JTC 1
ISO/IEC
7809

**Information technology — Telecommunications
and information exchange between systems —
High-level data link control (HDLC) procedures —
Classes of procedures**

**AMENDMENT 5: Connectionless classes of
procedures**

Reference number
ISO/IEC 7809 : 1991/Amd.5 : 1992 (E)

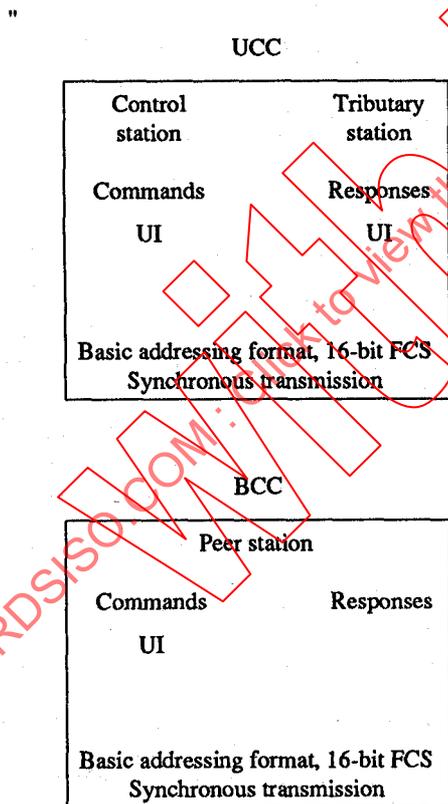
- o) In subclause 3.3 - insert the following sentence at the end of the paragraph:
"Options 2, 3, 4, 8, 9, 10, 11 and 13 are not applicable to the connectionless classes of procedures."
- p) In subclause 3.4 - change "three" to "five".
- q) In table 1, Options 2, 3, 4, 8, 9, 10, 11 and 13 - insert "(not for UCC or BCC)" at the end of the Functional description.
- r) In figure 5 - insert the following as a fourth and fifth Basic repertoire:

Commands	Responses
UI	UI

3.2.2.5 BCC

The basic repertoire of commands and responses for BCC shall be as follows:

Commands	Responses	
UI	"
